AGENDA

HISTORIC DISTRICTS REVIEW
BOARD
SEPTEMBER 24, 2024
5:30 PM
CITY COUNCIL CHAMBERS
CITY HALL
200 LINCOLN AVENUE

**City of Santa Fe
Historic Districts Review Board
Findings of Fact and Conclusions of Law**

**Façade diagram
409 Camino del Monte Sol**

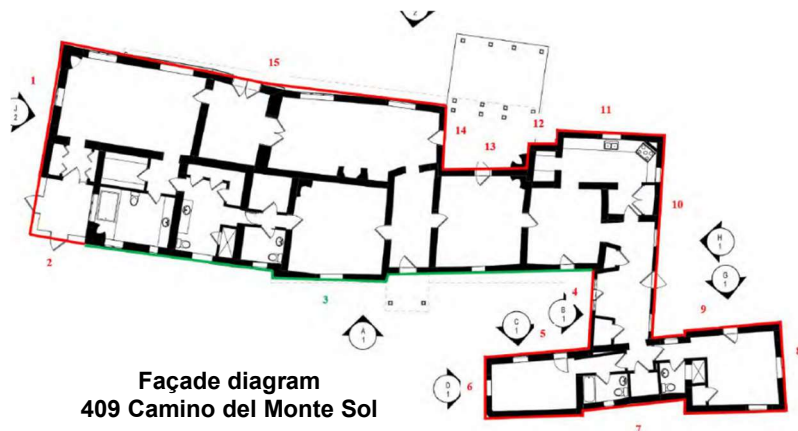
At this hearing, the Applicants asked the Board to review the structure’s historic status and designate primary façades, if applicable. The Staff recommended that the contributing status of this property be maintained, and that façade # 3, on the south elevation, be designated as the primary façade.

2. Historic Preservation Division Staff Recommendation: Staff recommended that the Board retain the structure’s contributing status, per SFCC Section 14-12.1, and that the Board designate the south-facing façade # 3 as primary.

11. The Board finds that the southern and northern façades identified on the façade diagram as #s 3, 13 and 14 are the primary elevations of the structure with the features that define the character of the structure’s architecture. The features include historic doors, windows, the porch, and the original, historic footprint.

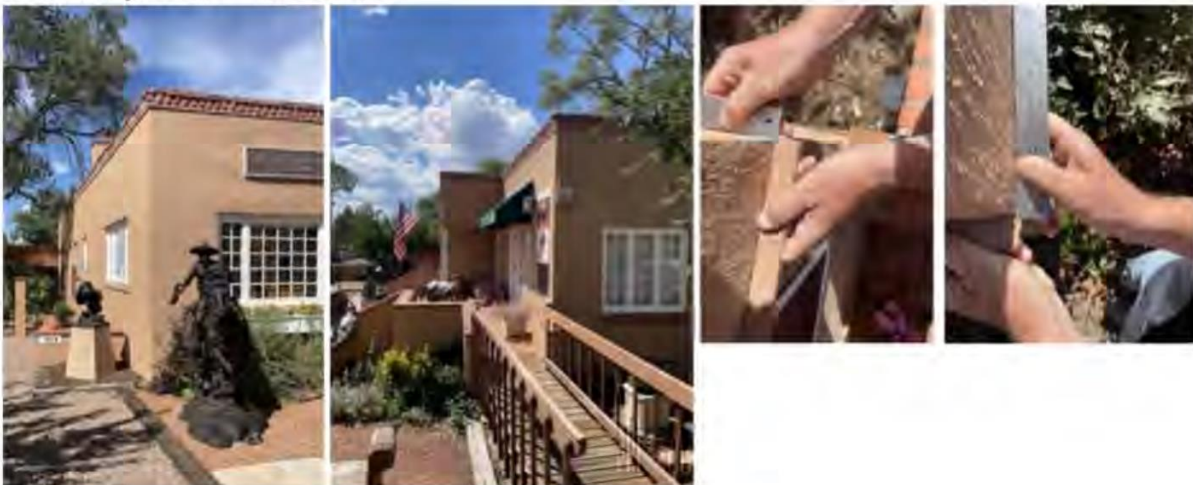
The new custom home to be built at 645 Garcia St. was reviewed at the Aug. 13th HDRB hearing and has been approved to proceed for building permit. At the hearing, HRDB stipulated that the to-be built structure shall have "eased" corners.

The new home construction follows the Recent Santa Fe Style standards. There is no specific standard that specifies how sharp or bullnosed the corners must be. Accordingly, we kindly request 1/4" eased (rounded) corners.

Included in the BOARD ACTION follow up letter provided by Staff, it was noted the discussed 'eased' corners should be 1" or more rounded corners. As HRDB did not specify the dimension of the "eased" edge, and we would like to build 1/4" eased edges, we were advised by Staff to return to HRDB for clarification. We greatly appreciate HRDB's time, resources and consideration in clarifying this matter, and sincerely apologize for any inconvenience or misunderstanding that has cost unnecessary time.
